# Access Compliance Report

## Public Rights-of-Way

Intersection ID: 27190	Main Street: BALLANTYNE COMMONS PY	Cross Street: WOODVIEW CR	Location: NW
ADA ID: 52AA62C3CF6B	Ramp Type: BlendTrans2	Initial Pass/Fail: Fail	Overall Compliance: No
		Severity Score: 8.75

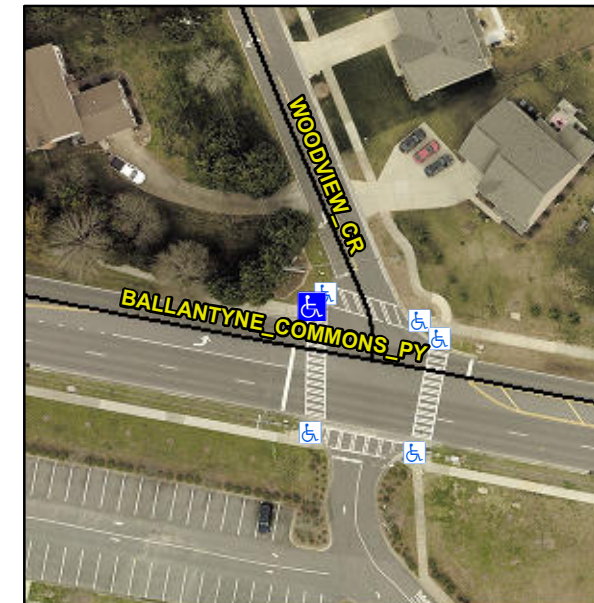
Compliance	Description	Data	Compliance	Description	Data
N/A	Ramp Length (in)	72.0	Yes	BlendTrans Slope (%)	1.9
No	Ramp Width (in)	38.0	Yes	BlendTrans XSlope (%)	0.5
N/A	Flare Type LT	N/A	N/A	Flare Type RT	N/A
N/A	Flare Slope LT (%)	N/A	N/A	Flare Slope RT (%)	N/A
N/A	Flare Traversable LT?	N/A	N/A	Flare Traversable RT?	N/A
N/A	Landing Length (in)	N/A	N/A	DWS Provided?	N/A
N/A	Landing Width (in)	N/A	N/A	DWS Contrast?	N/A
N/A	Landing Slope (%)	N/A	N/A	DWS Length (in)	N/A
N/A	Landing X Slope (%)	N/A	N/A	DWS Full Width?	N/A
N/A	Landing Curb? (Y/N)	N/A	N/A	DWS Offset (in)	N/A
N/A	Shared Landing?	N/A			
N/A	Gutter Ponding?	N/A	N/A	Gutter Slope (%)	N/A
N/A	Gutter Lip Ht (in)	N/A	N/A	Gutter X Slope (%)	N/A
N/A	Painted X Walk1?	Yes	N/A	Painted X Walk2?	N/A
	X Walk 1 Direction	To S		X Walk 2 Direction	N/A
	X Walk 1 Width (in)	109.0		X Walk 2 Width (in)	N/A
	X Walk 1 Slope (%)	1.2		X Walk 2 Slope (%)	N/A
	X Walk 1 X Slope (%)	2.5		X Walk 2 X Slope (%)	N/A

**Remove & Replace Curb Ramp With Two New Directional Ramps or Equivalent.**

**R304.5.1**
